CITY OF WORCESTER, MASSACHUSETTS

Subject: **Bid No. 7694-W2, Vehicles, School Buses / WPS**

ADDENDUM NO. 3

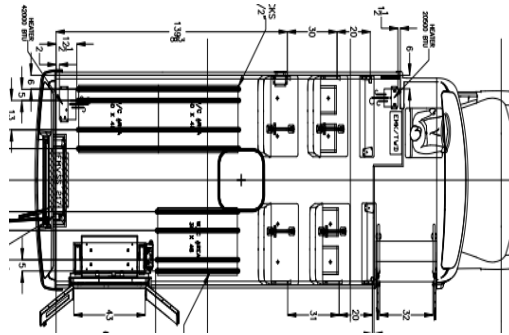
- Under the Type A specifications, we just want to make sure you are looking to have 8 total seated passengers with 3 open spots for wheelchairs. Please see floor plan picture below. We want to make sure that the track integrated into the floor for the wheelchair hold downs is what you are looking for while the 4 front seats are stationary mounted. We just want to clarify that you are not asking for full track seating throughout the entire bus.

Answer: Correct, as specified, 8 seated and 3 wheelchair.
